CRIGLER ADDITION

WICHITA, SEDGWICK COUNTY, KANSAS

Re: S/D 95-80 CRIGLER ADDITION (Final Plat)

CASE NUMBER: S/D 95-80 CRIGLER ADDITION

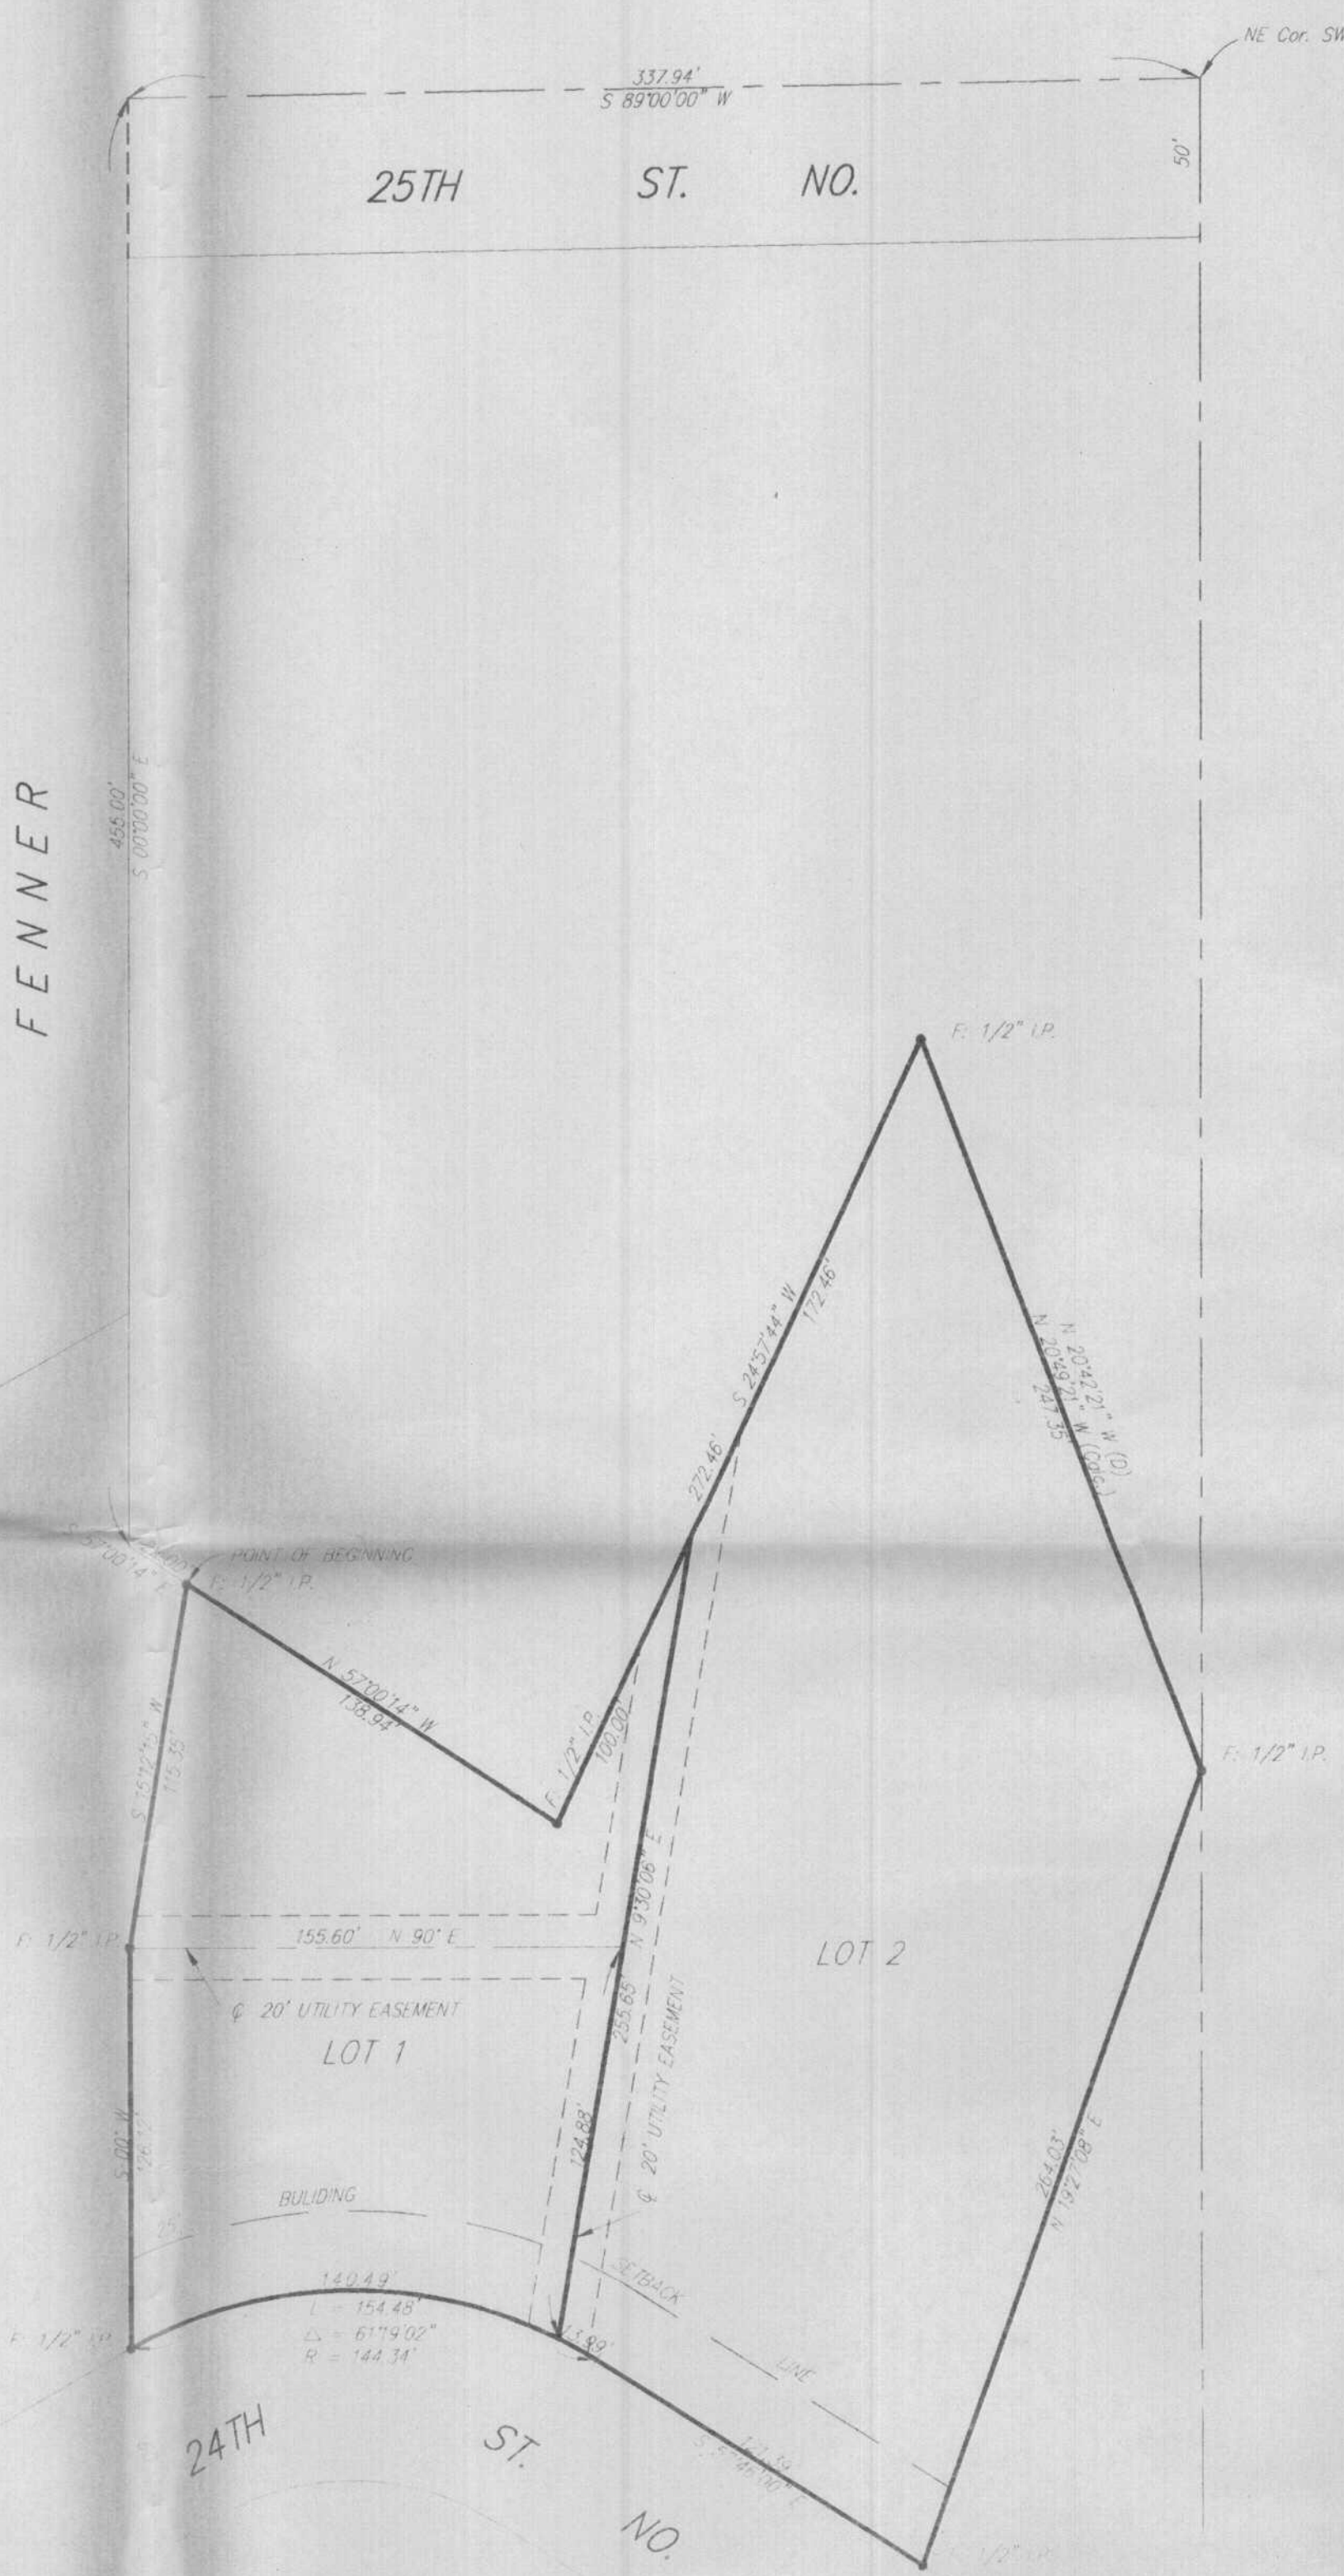
- ☒ E. On the final plat tracing, the common lot line between Lots 1 and 2 shall be drawn at the same thickness of the other lot lines. As now drawn, it is somewhat uncertain as to line being a lot line or just a center line for the adjacent 20-foot easement.

- ☒ F. *don't do - still using Tie to sec.*
On the final plat tracing, it appears that a tie point from one of this Addition's lots (Lot 1) can and should be established from an adjacent existing lot.

- ☒ G. *still shows Nancy*
On the final plat tracing, the MAPC signature block shall be amended to indicate Susan Osborne-Howes as the chair(man).

- ~~J.~~ The applicant's agent is advised that while the street to the northwest of this site was platted as Ethel, recent maps are showing all or the north-south section as having the name Fenner (Place). The final plat tracing shall correctly indicate the name as Fenner for this street segment.
